MEMORANDUM

From:	Service Manager Environment	To:	Head of Community Well-being and Development
Our Ref:	ENV/DC/PP/2015/0812	Your Ref:	MP/P/2015/0812
Date:	13 th January 2016

Location: O. S Grid Ref: 330 513 Land North of Total Fitness Ltd, Stansty Road, Wrexham.

Development: Residential Development (24 no. dwellings) together with highways, access and parking arrangements.

Turning Areas

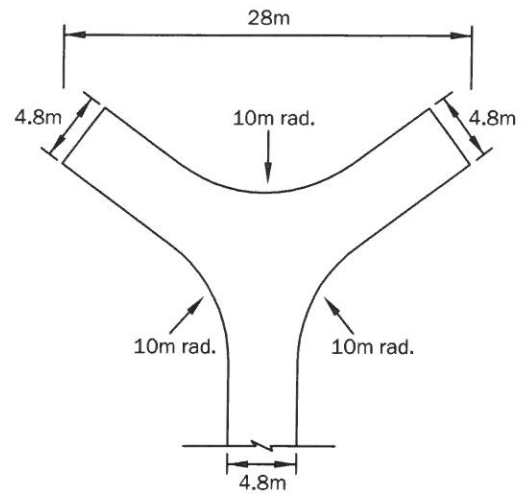
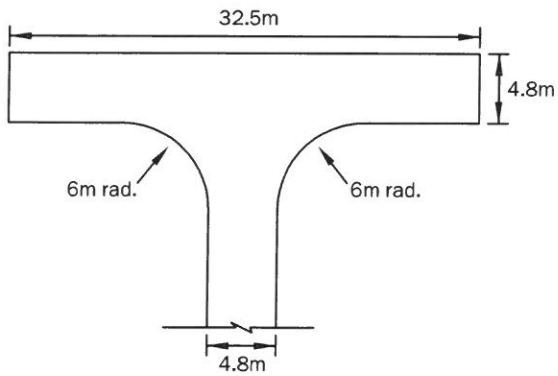
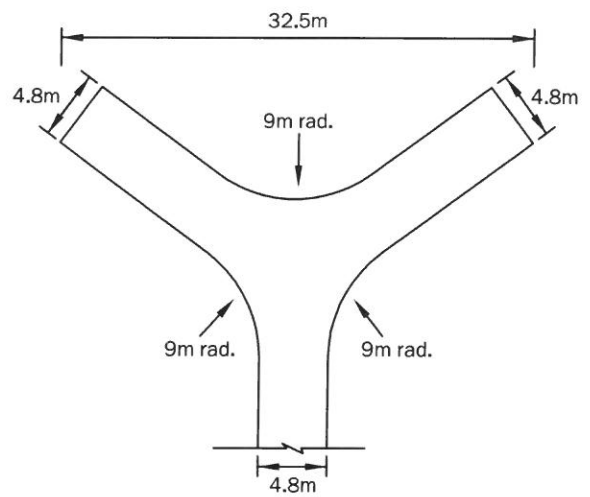
The proposed turning head fronting plot nos. 19 & 20 has not been amended as previously requested and is inadequate and does not meet our current standards. This will need appropriate footways / service strips around its perimeter which will impact on the number of parking spaces that can be provided in this location. **I would recommend that the applicant incorporates a turning head meeting our current standards (see attached detail) and reviews the number of parking spaces / dwellings that are achievable in this location. Please ask the applicant to indicate this detail on a revised layout plan.**

The parking provision for plot nos. 13 – 17 appears quite tight. The proposed layout will need to be re-configured in order to provide a suitably sized turning head (see attached detail). **I would recommend that the applicant amends the proposed turning head and parking provision in this location providing driveways that comply with the attached details.**

Turning areas are based on an 11.18m long, 2.55m wide refuse vehicle.

7.5t Panel Van
 Overall Length
 Overall Width
 Overall Body Height
 Min Body Ground Clearance
 Track Width
 Lock to Lock Time
 Kerb to Kerb Turning Radius

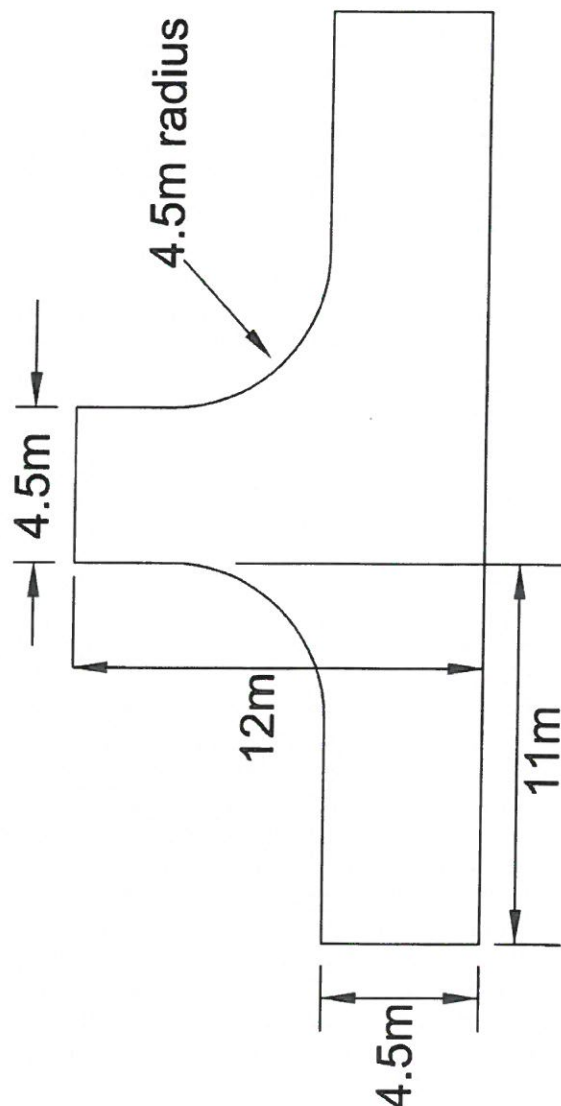
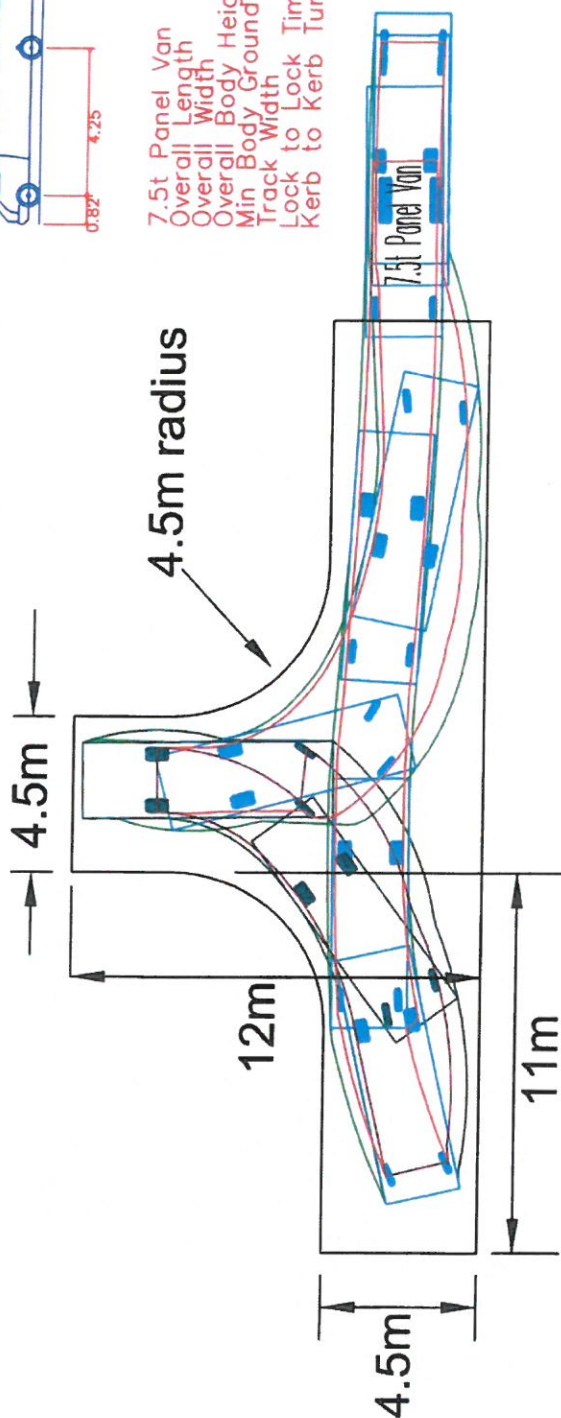
The private driveway serving plot nos. 1 – 6 has no turning head. **I previously recommended that this driveway is provided with a suitable turning head to accommodate the turning movements of a medium sized HGV / typical delivery vehicle (see attached detail). This will avoid the need for such vehicles to back out onto the main estate road or have to reverse in. Such detail has not been provided. Please ask the applicant to indicate this detail on a revised layout plan.**
